Regarding: 353 N. Claremont Street

The purpose of this letter is to outline to you the issues involved with the repair and rehabilitation of the house located at 353 N. Claremont Street in San Mateo. It is my opinion that the following scope of work meets the Secretary of the Interior's Standards for Rehabilitation and presents no adverse affect on the historic property, so long as work is carried out in accordance with the outlined scope. Enclosed are photographs which will help to illustrate the proposed work.

SCOPE OF WORK:

1,6

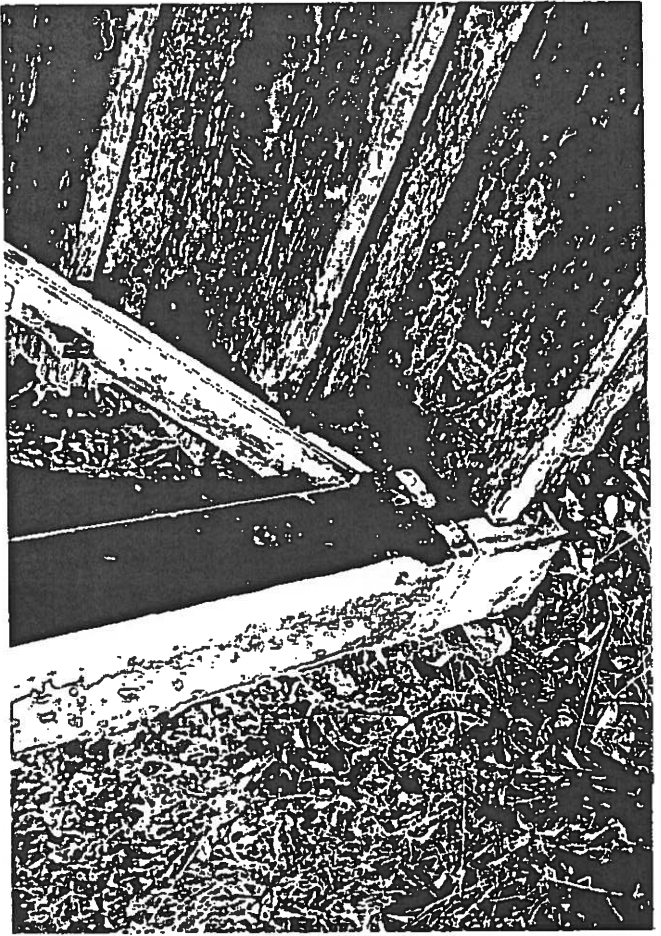
1. Remove existing rotted wood decking and replace with new tongue and groove decking to match in material and dimension.

4. The existing newel posts appear to be original, but have been modified at the bottom, and a steel angle has been attached to one side. Remove the steel angle, and patch and repair all holes. Remove the newer portion of bottom posts and reconstruct new sections which provide a snug joint with the original newel posts. Provide an epoxied dowel connection if necessary for structural support.

6. Install clear glass in missing panel of original front door. Repair and reinstall existing non-original screen door.

3

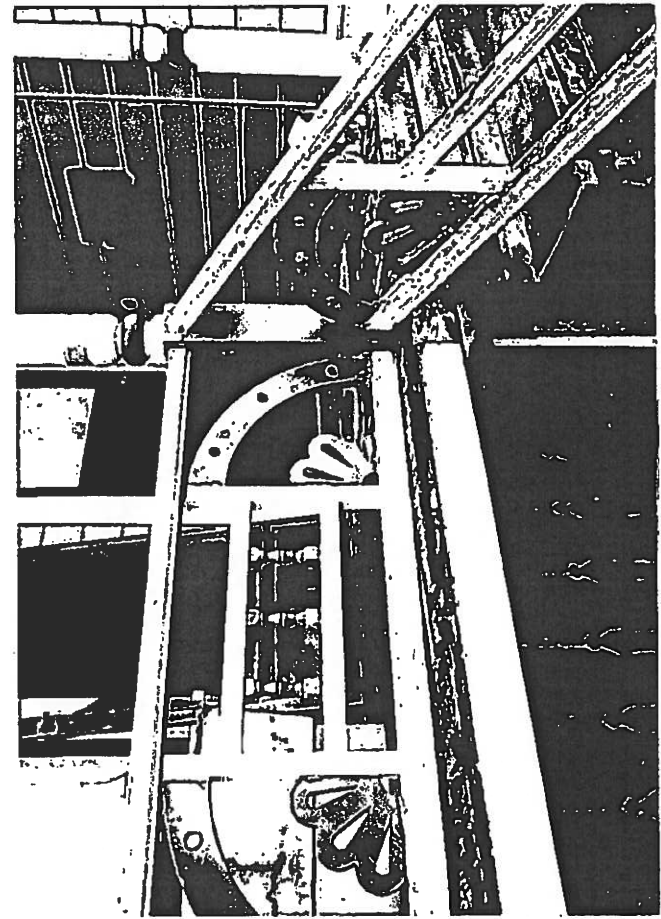
3. Scrape, sand, prep, and repaint existing original stair railings. Repair or replace only those portions which are rotted. At the bottom of the railing where fretwork details are missing, reconstruct new wood detailing, based on the pattern and rhythm of similar rail fretwork.

2

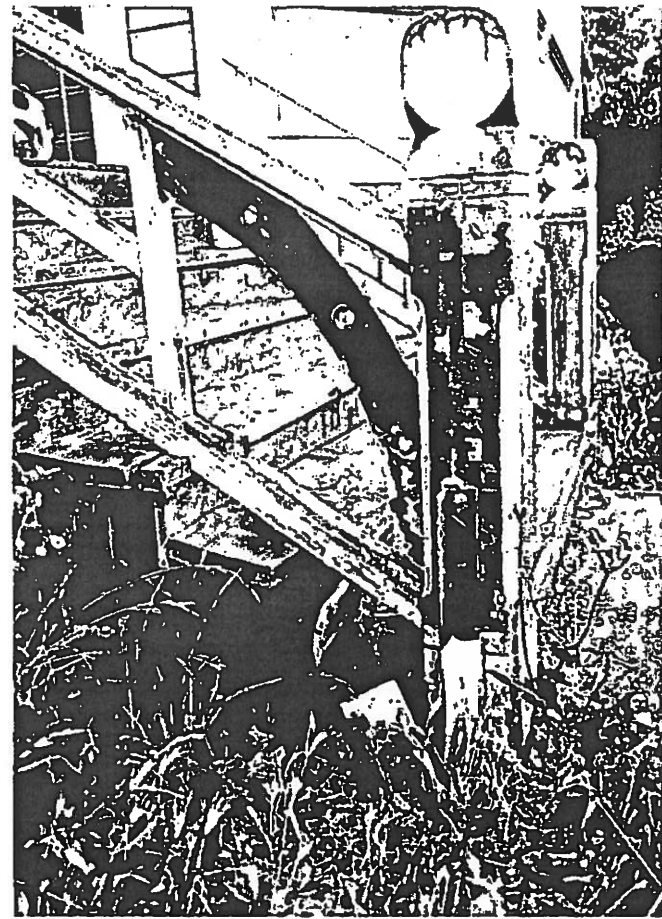
2. Remove rotted risers and treads and replace in kind. Notches in existing treads indicate that the original steps have been replaced. New treads and risers should be detailed to relate to the angle of the bottom rail so that the new treads do not need to be notched.

9

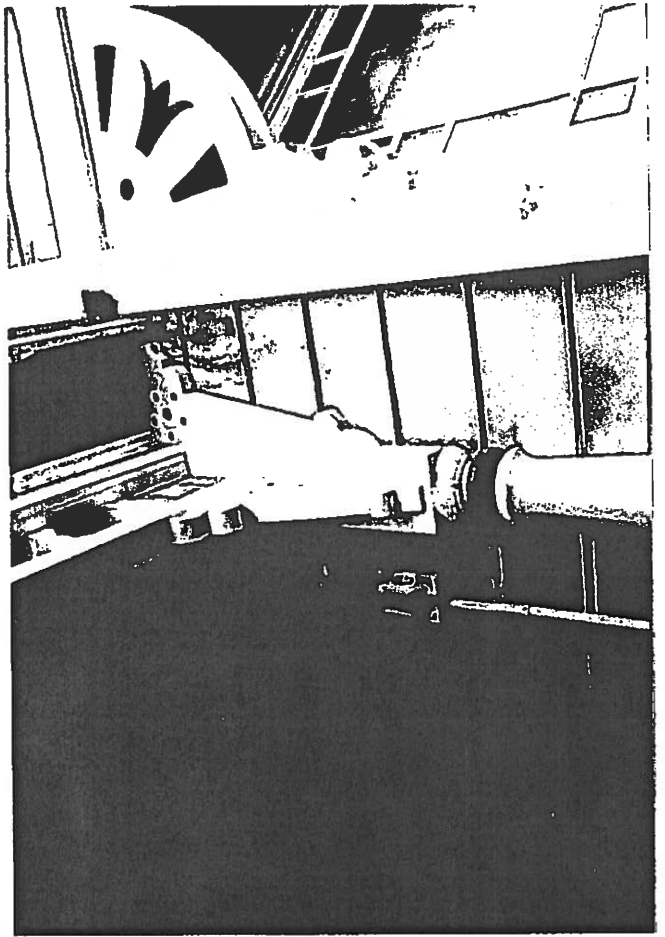
9. Remove non-operable electrical panels from front porch wall. Make necessary repairs to existing wood siding.

8

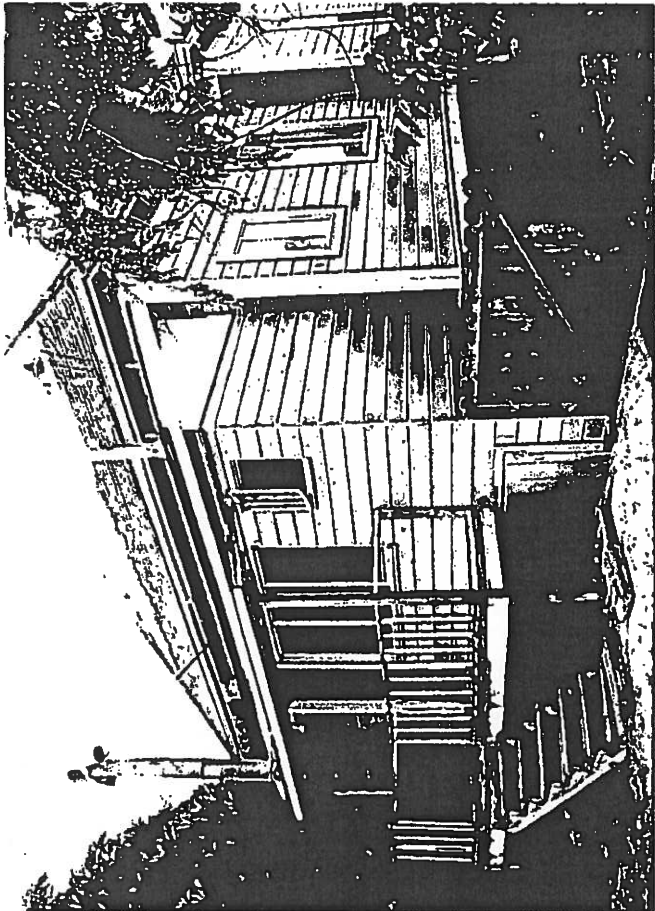
5. The entire rear porch and deck is a later addition to the original structure. Remove existing rotted deck and reconstruct a new wooden deck and stairs. New construction will be unroofed and compatible with the historic character of the house.

8. Remove aluminum sash from the larger of the side window openings. Install new operable 1/1 wood sash of a profile to match existing original sash. Leave existing trim in place. (It is my opinion that a pair of windows were originally located in the center of this wall, and were replaced with the existing configuration at a much later date.)

7

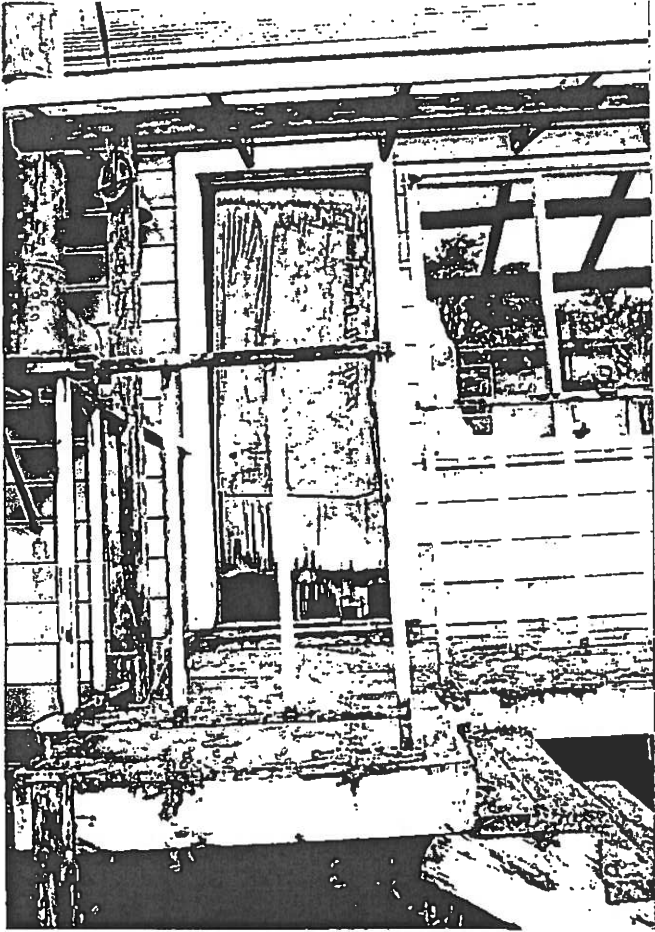
7. Remove existing non-original rear door and install a new door of simple design.

10

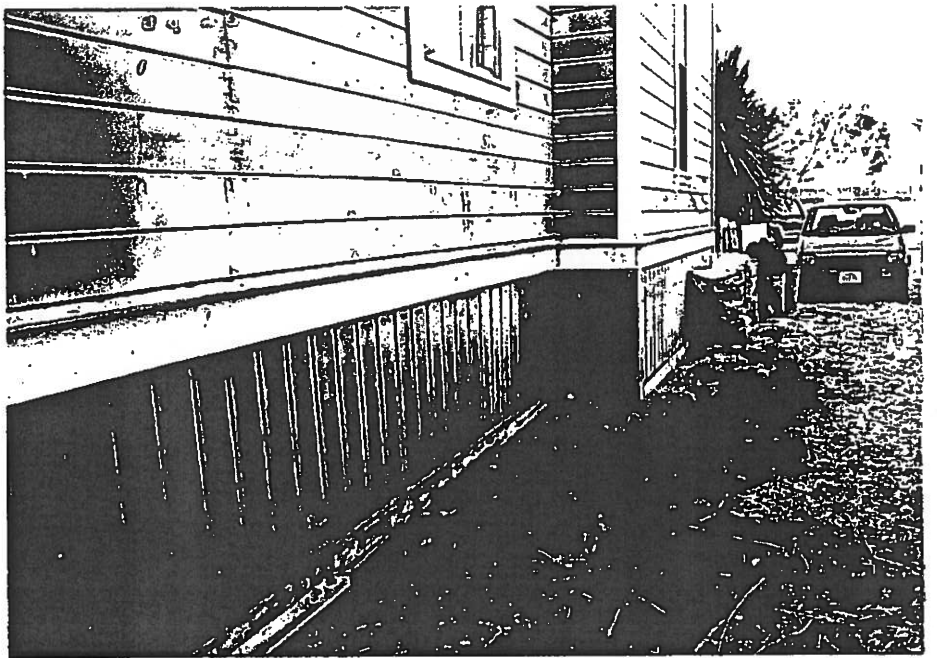
10. Existing drainage at the south side of the house currently drains toward the wood-finished wall. This is an undesirable situation which should be alleviated. My suggestion is to regrade the unpaved drive-way to allow for drainage away from

the house rather than toward it. The installation of a French drain under a gravel base would also be very beneficial. A complete survey of the perimeter of the house should be conducted and poor drainage areas reworked for positive drainage away from the residence.

11. Install flush-mounted soffit vents as needed to provide positive attic ventilation. Vents should be wooden inserts, painted to match the soffit.
